DrawDiff Comparison Report

Part number: P-001 | Job: ab7f5e43-e2c9-4333-97f0-7f3a16fe3feb | Generated: 2026-05-04T23:39:07+00:00

ISO_LEFT [MATCHED]

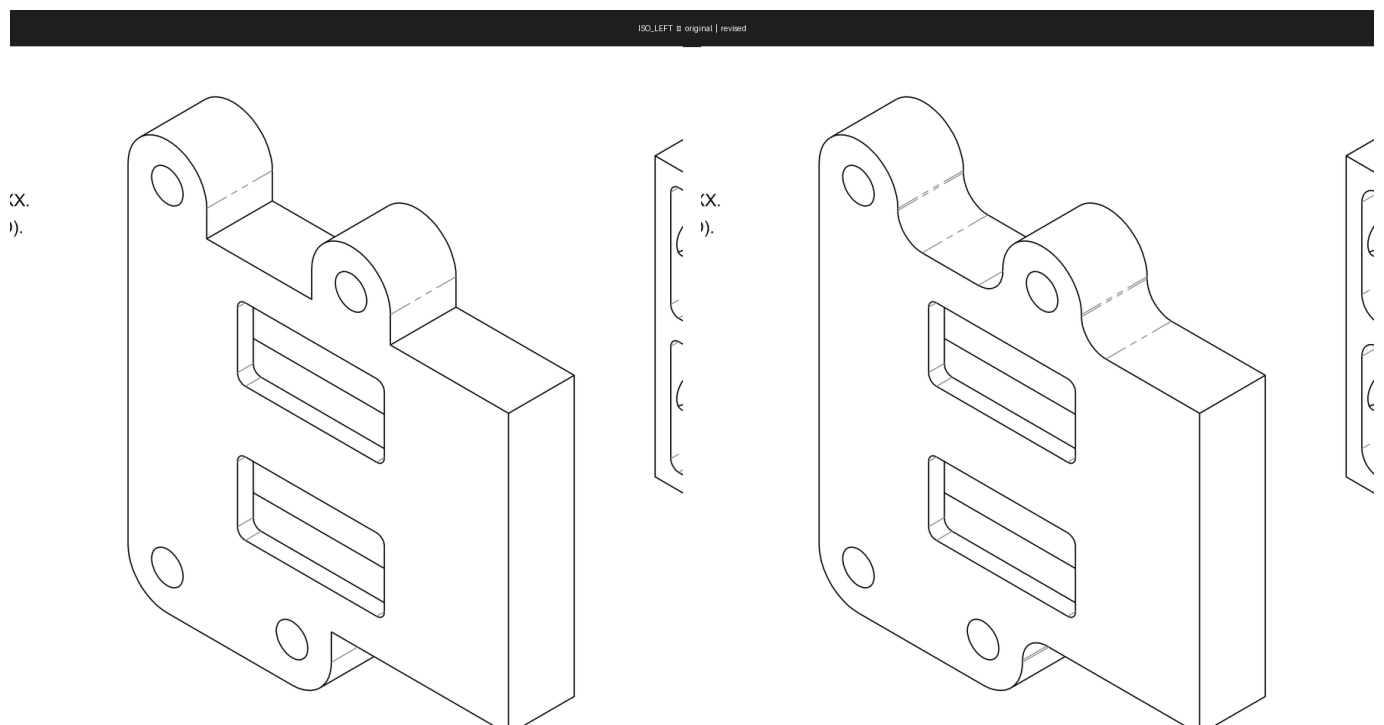
Severity	Field	Original	Revised	Conf.	Rationale
SIGNIFICANT	geometry	Upper hinge/pivot bracket has flat-topped cylindrical	Upper hinge/pivot bracket has continuous curved/filletted profile	0.82	The upper pivot boss area changed from a stepped/ square-shouldered profile to a

Severity	Field	Original	Revised	Conf.	Rationale
		boss with sharp square shoulder transition to body	transitioning smoothly from the round boss down to the body without a square shoulder step		fully blended curved fillet, which alters the stress concentration geometry and potentially the fit of mating hinge components.

ISO_RIGHT [MATCHED]

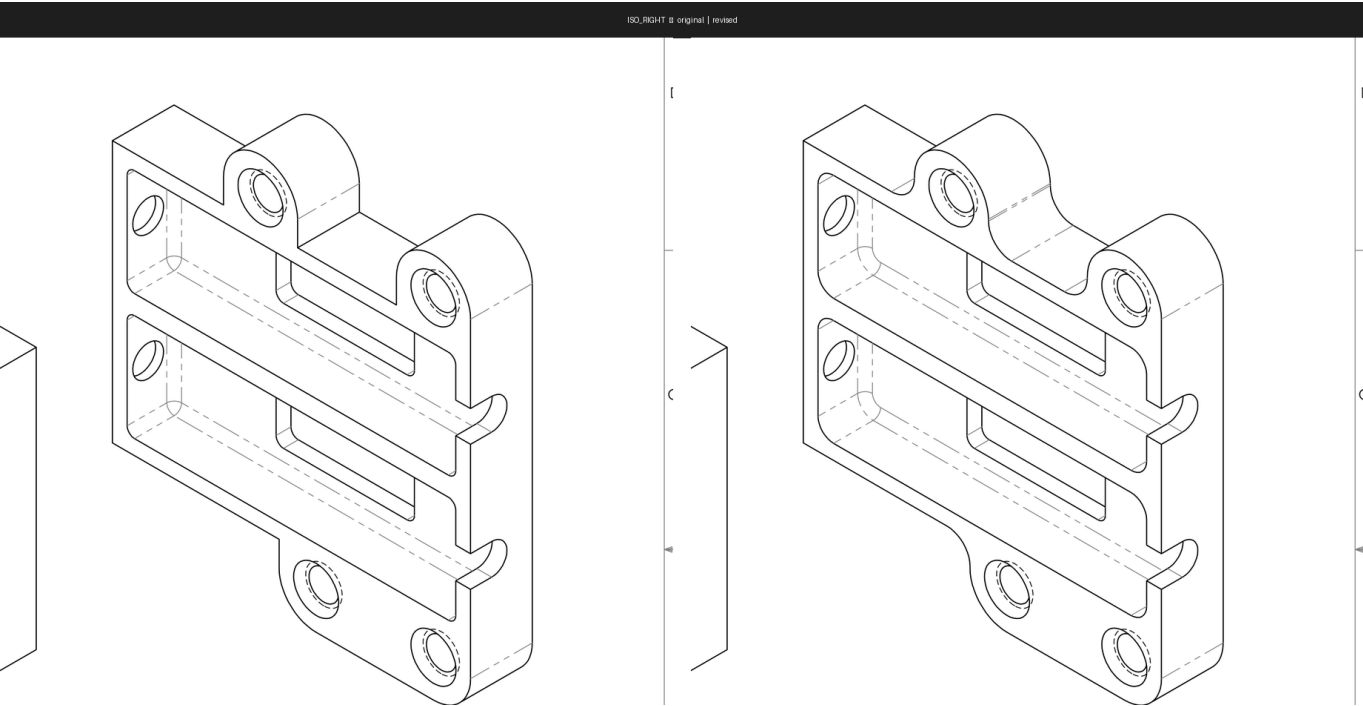
Severity	Field	Original	Revised	Conf.	Rationale
SIGNIFICANT	geometry	Sharp/square corner at upper-left front edge of top flange (no fillet visible)	Fillet/radius added at upper-left front edge of top flange	0.75	The revised view shows a visible fillet radius on the upper-left corner of the top flange area where the original had a sharp corner, indicating a geometry change that affects stress concentration and potentially fit with mating parts.

SECTION B-B [MATCHED]

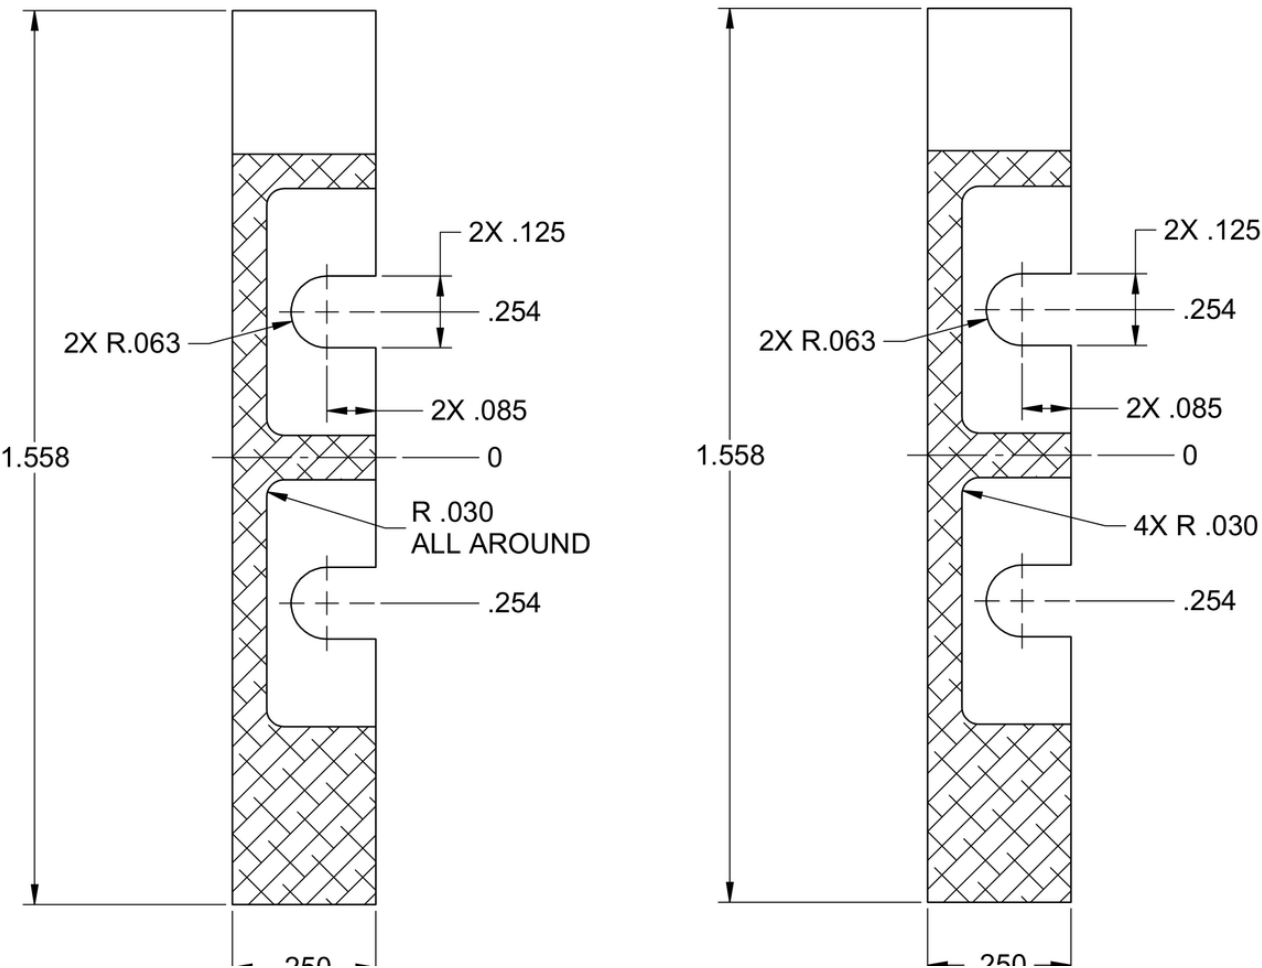
Severity	Field	Original	Revised	Conf.	Rationale
SIGNIFICANT	callout	R .030 ALL AROUND	4X R .030	0.92	The radius callout changed from 'ALL AROUND' (implying continuous application around the full profile) to '4X' (explicitly counting 4 discrete instances), which alters the manufacturing scope and inspection criteria for this fillet/radius feature.

FRONT_VIEW [MATCHED]

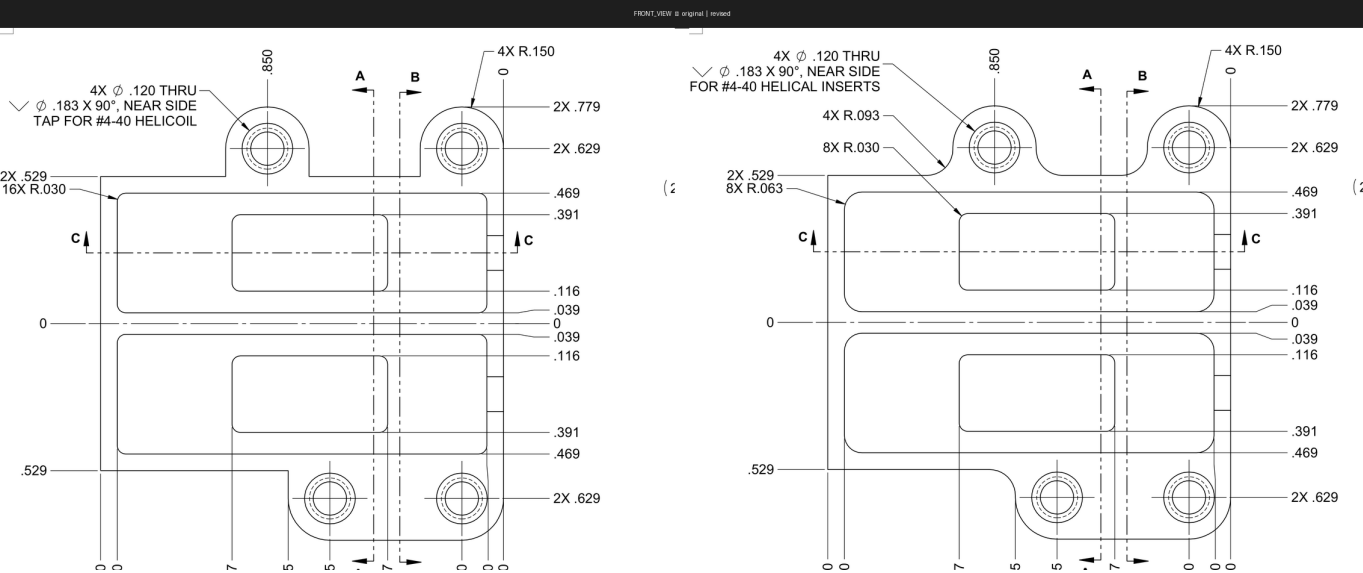
Severity	Field	Original	Revised	Conf.	Rationale
SIGNIFICANT	note	TAP FOR #4-40 HELICOIL	FOR #4-40 HELICAL INSERTS	0.92	The insert specification note was changed from 'TAP FOR #4-40 HELICOIL' to 'FOR #4-40 HELICAL INSERTS', which alters the manufacturing callout for the threaded insert installation process and brand/ type designation.
SIGNIFICANT	annotation	16X R.030	8X R.030	0.90	The quantity multiplier for the R.030 radius callout was reduced from 16X to 8X, indicating fewer instances of this radius feature are now specified on the part.
SIGNIFICANT	geometry	Upper pocket with sharp/small corner radii consistent with 16X R.030 only	Upper pocket geometry updated with additional R.093 and R.063 radii features	0.80	The pocket corner geometry in the upper half of the part appears to have changed shape, consistent with the addition of the R.093 and R.063 radius callouts replacing or supplementing some of the previously specified R.030 corners.

SECTION A-A [MATCHED]

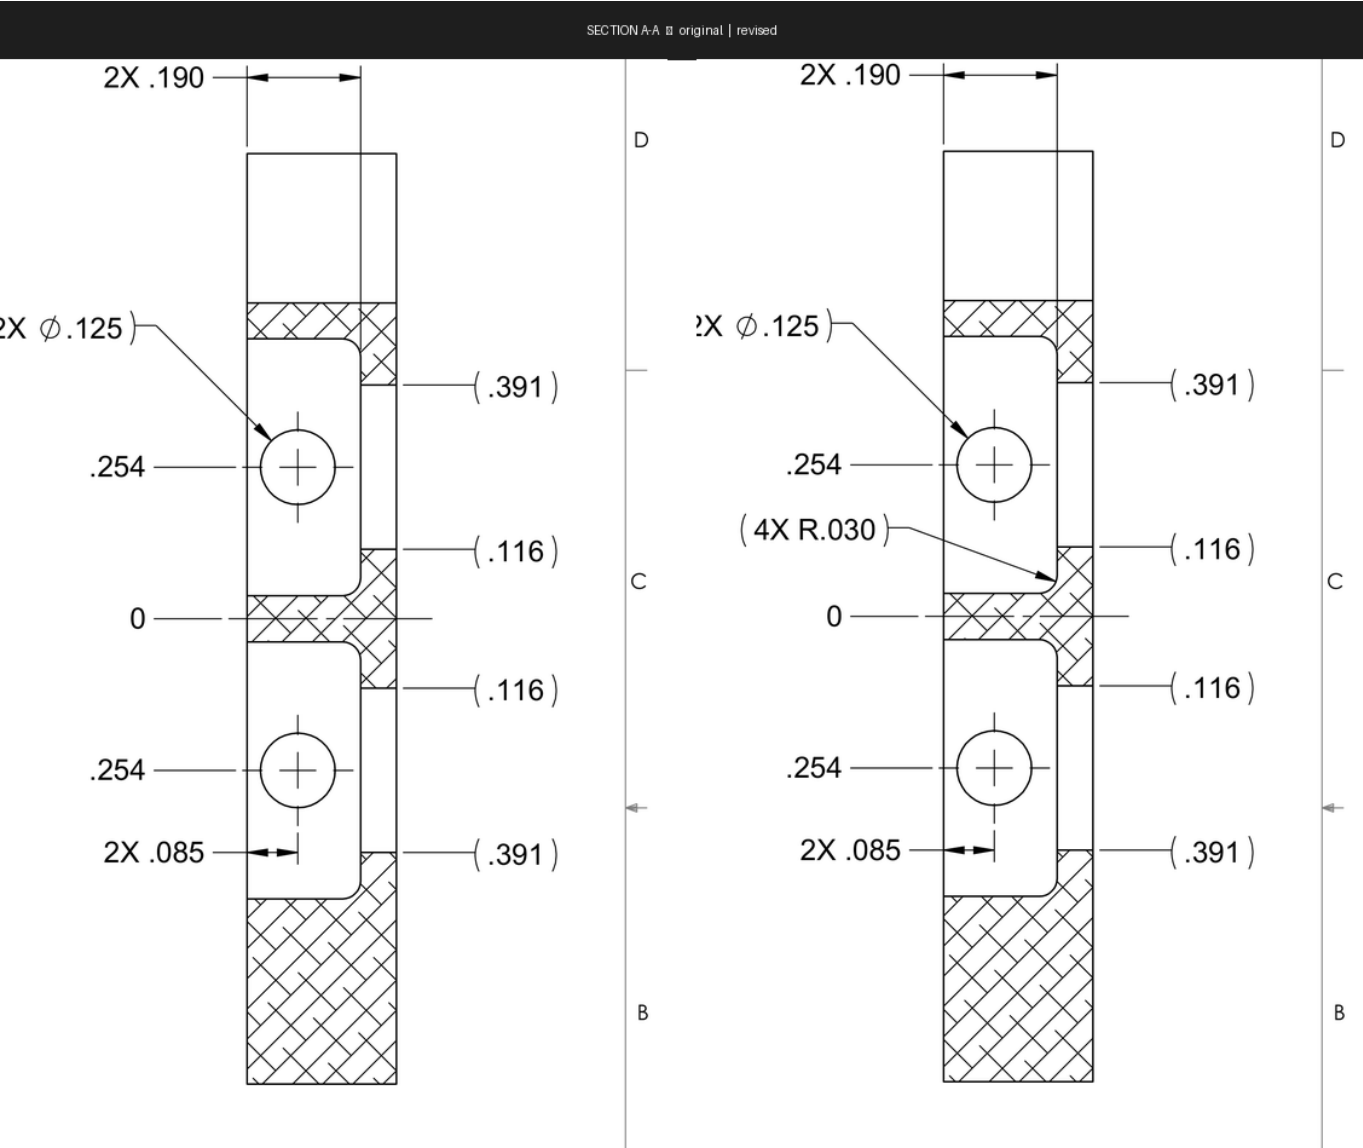
Severity	Field	Original	Revised	Conf.	Rationale
SIGNIFICANT	annotation	—	(4X R.030)	0.92	A new reference callout for 4 corner radii of R.030 has been added in the revised drawing, specifying fillet/ corner radii at the slot transitions that were not previously called out, which affects machining requirements.

SECTION C-C [MATCHED]

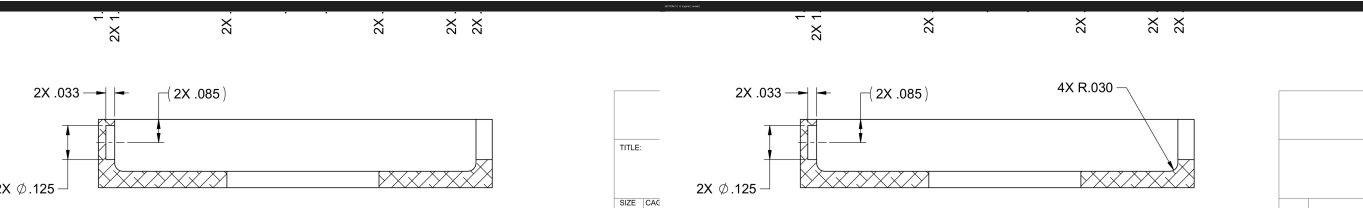
Severity	Field	Original	Revised	Conf.	Rationale
SIGNIFICANT	callout	—	4X R.030	0.92	A new radius callout '4X R.030' has been added in the revised drawing, specifying four corner radii that were not

Severity	Field	Original	Revised	Conf.	Rationale
					previously called out, which affects part geometry and manufacturing requirements.
